BCA Assessment Report

2022 SCEGGS Wilkinson House

Reference No: 114039-BCA-r1

Date: 19 November 2021

2.6. Fire Compartments

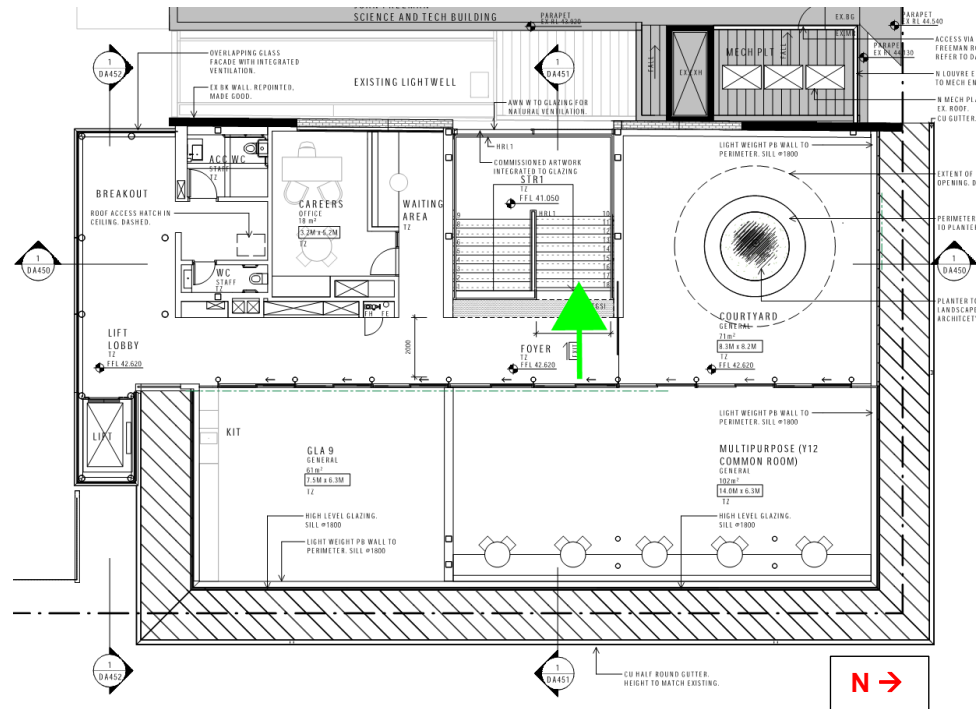
The following *fire compartments* have been determined:

(a) Ground Floor (L00) through to Level 3 (L03) as connected via the central open stairway	-	~ 1 800m ²
(b) Lower Ground Floor (LG)	-	~ 450m ²

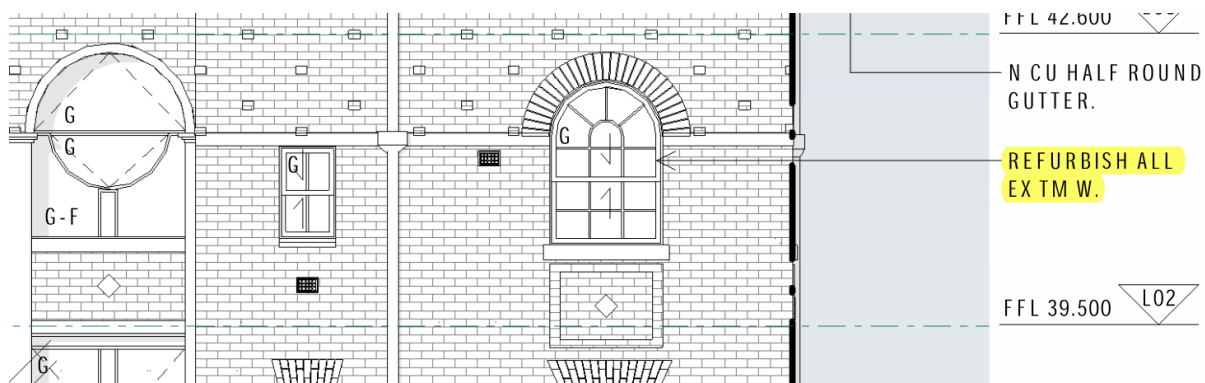
It is also noted that this clause also prohibits the use of in situ formwork containing combustible elements including PVC lined formwork products where the PVC lining remains in place for the life of the building where proposed to be used as an external wall element, common walls, the flooring and floor framing of lift pits, services riser shafts or non-loadbearing internal walls required to be fire resisting.

With reference to the proposed Elevation drawings, with part of the East elevation re printed below, the 2022 SCEGGS Wilkinson House project is a complete re-build except that the existing brick heritage façade is to remain. With this, existing timber framed casement windows are to be refurbished and converted from single to double hung on a maintenance upgrade basis. Whilst it is acknowledged that timber framed windows are combustible, it must be recognised that the facades of the building to remain are existing and do not form part of the scope of works of the 2022 SCEGGS Wilkinson House project.

3.5. BCA Part A7 & D1.11 - United Building and Horizontal Exits

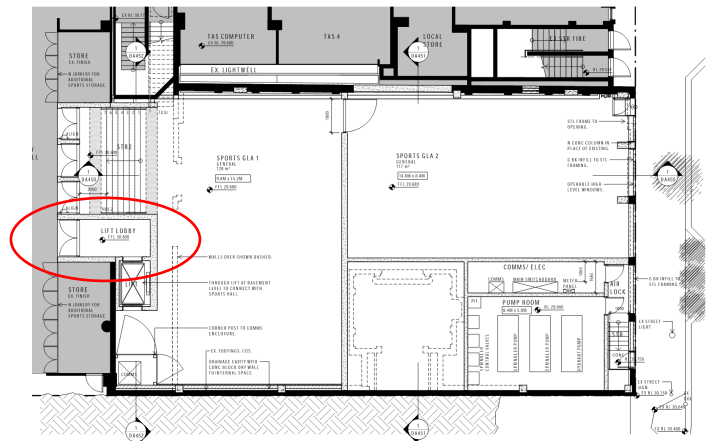
For this reason and given that the Wilkinson House proposal will utilise and share the fire isolated stairway at the north eastern corner of the Joan Freeman building that abuts, with exits into the Joan Freeman stairway proposed at Levels 1 (L01) and Ground (L00), the proposed Wilkinson House re-build and the Joan Freeman building must be considered a United building as defined by BCA Part A7.

For the ongoing detailed design and Construction Certificate phase of the 2022 SCEGGS Wilkinson House project works, configuring and alignment of the fire safety measures and their standards of performance of the two buildings will need to be comprehensively documented.

In addition to the shared fire-isolated stairway and fire services, the 2022 SCEGGS Wilkinson House project works, as detailed at item 2.7 above, proposes to create a horizontal exit to the Joan Freeman building at the south western corner of proposed Level 1 (L01).

In addition, 'horizontal exits' albeit to another building that is not considered united being the Centenary Sports Hall building to the south, are proposed to serve proposed Levels 2 (L02) and Lower Ground (LG). These 'horizontal' exits to another building that is not united, will require a performance based solution.

3.7. BCA Clauses D1.3 & D1.7 - Fire Isolated Exits

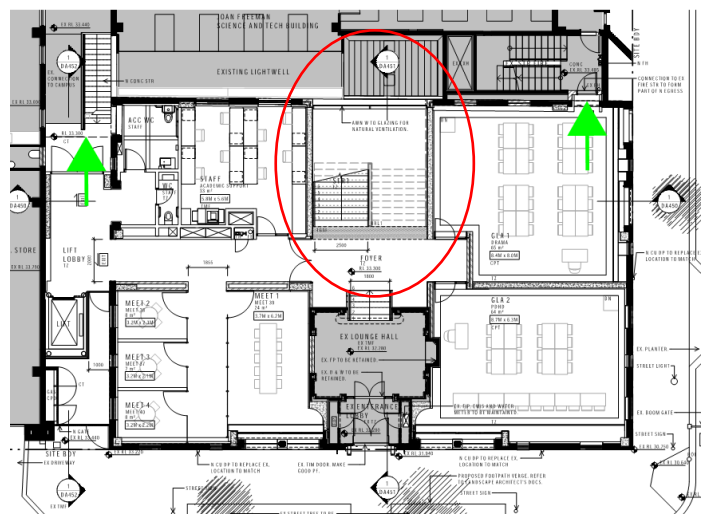
The central open circulating stairway serving Levels 3, 2, and 1 and discharging and connecting to the Ground Floor connects four storeys, in lieu of being a fire isolated stairway separated from the whole building and discharging directly to outside the building. This will require a performance based solution.

3.9. BCA Clauses C2.7(c) - Separation by Fire Walls

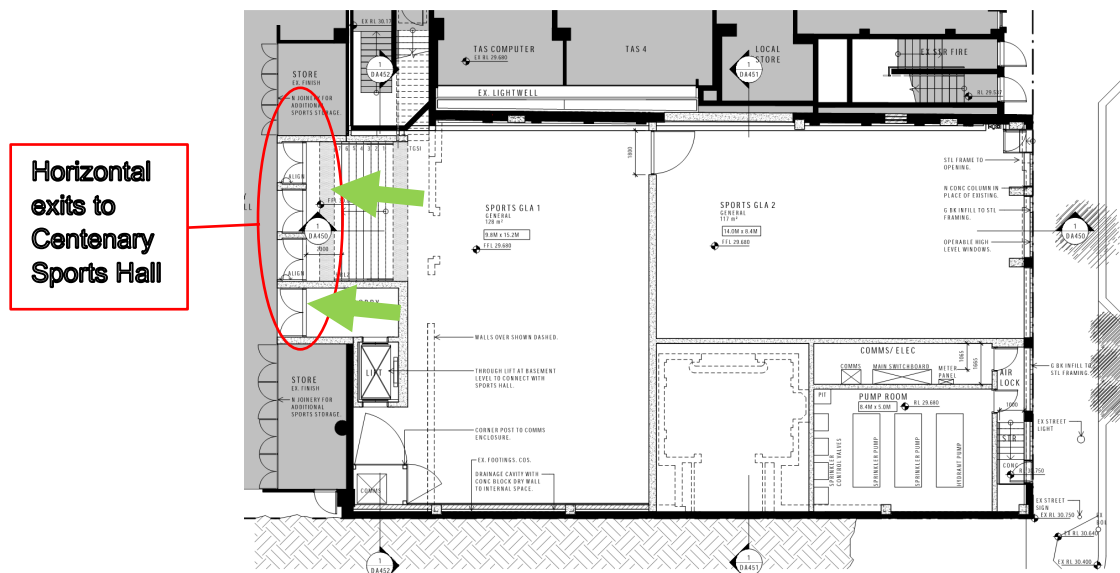
With the uniting of the Wilkinson House and Joan Freeman buildings, a horizontal exit to the Joan Freeman building at the south western corner of proposed Level 1 (L01) is proposed. In addition, 'horizontal exits' albeit to another building that is not considered united being the Centenary Sports Hall building to the south, are proposed to serve proposed Levels 2 (L02) and Lower Ground (LG).

These horizontal exits necessitate the provision of C2.7(c) fire walls to separate fire compartments and to C2.7(b) fire wall separate the Wilkinson House from the Centenary Sports Hall buildings.

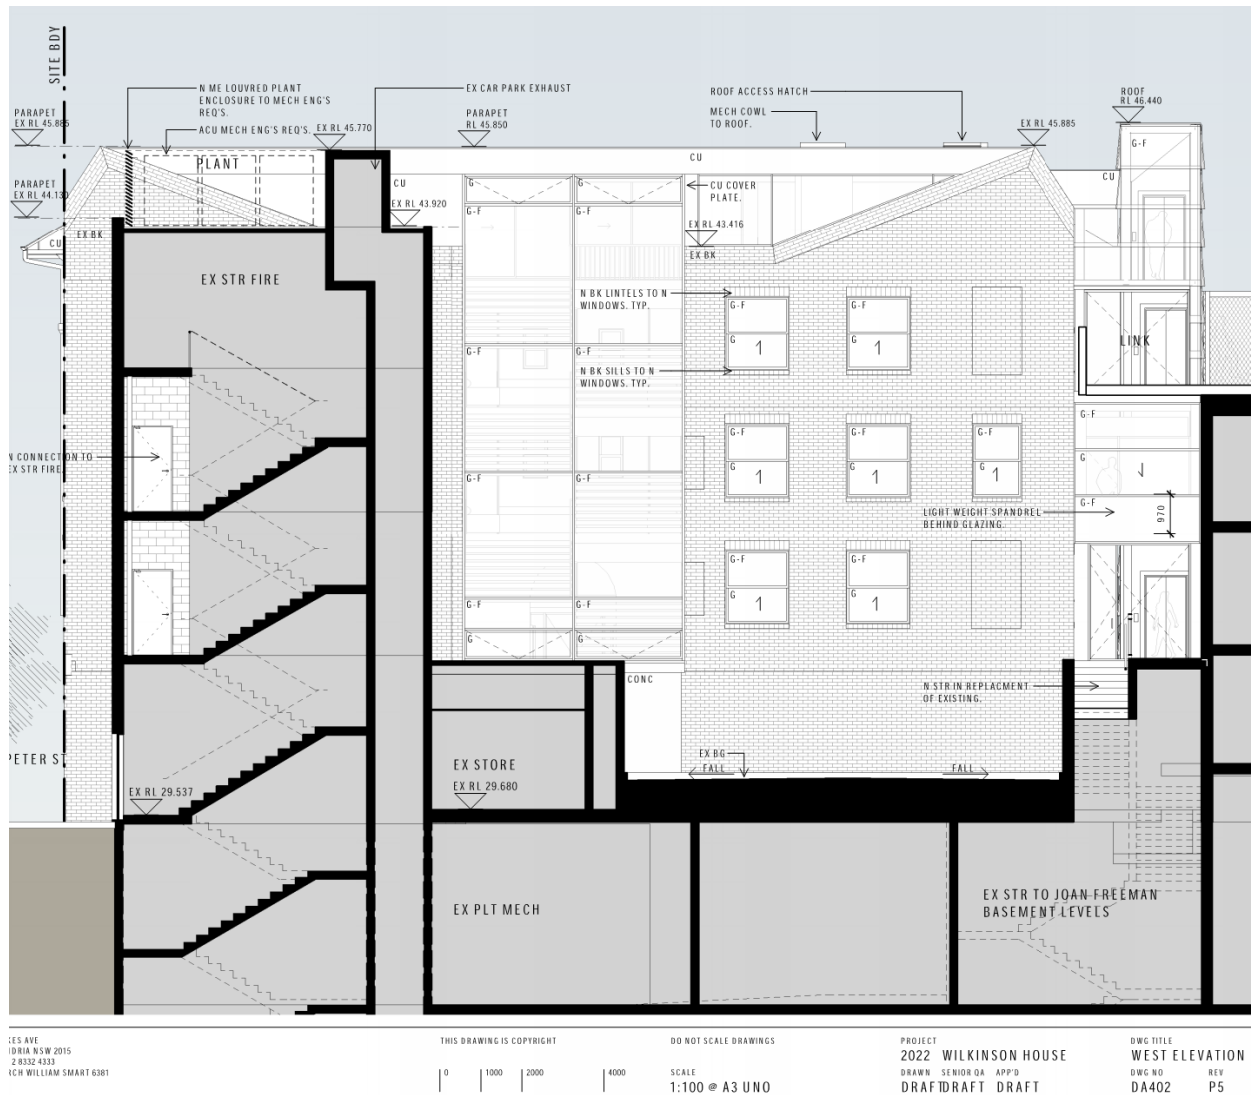
Subject to the new glass wall 'lift lobby box' of the upper levels of the southern elevation being protected by external wall wetting sprinklers (refer to screenshot overleaf), Clause 2.5(d) of BCA Specification C1.1 does not require a fire resistance level for these new glass walls situated less than 3m from the Centenary Sports Hall building. However, note that this precludes the ability to have any openable windows or 'ventilators' within 3m of the Sports Hall. This includes any openings to the eastern or western return walls of the glass box that are within 3m of the Sports Hall.

Furthermore, for the existing windows of the existing heritage southern elevation, scaled at ~2.7m from the Centenary Sports Hall building, BCA Clause C3.2 requires the existing windows to be protected from the 'fire source' (other building) in accordance with BCA Clause C3.4, being:

- (a) external wall wetting sprinklers to permanently fixed shut windows/ or automatically closing windows; or
- (b) -/60/- FRL fire windows, permanently fixed shut or automatically closing; or
- (c) -/60/- FRL fire shutters; or
- (d) or a fire engineered performance based solution.

3.12. BCA Clause D2.7 – Installations in Exits and Paths of Travel

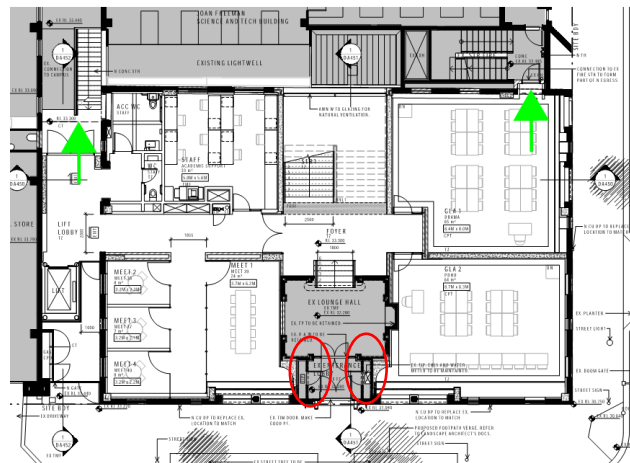
The ground floor (L00) heritage entry lobby has a Comms and DB cupboard that will need to strictly comply with BCA Clause D2.7 which requires any electricity meters, distribution boards or ducts, or telecommunications distribution boards installed in corridors/hallways/lobbies or the like to be enclosed with *non-combustible* construction or a fire protective covering (including ceiling void separation) with doorways suitably sealed against smoke spread.
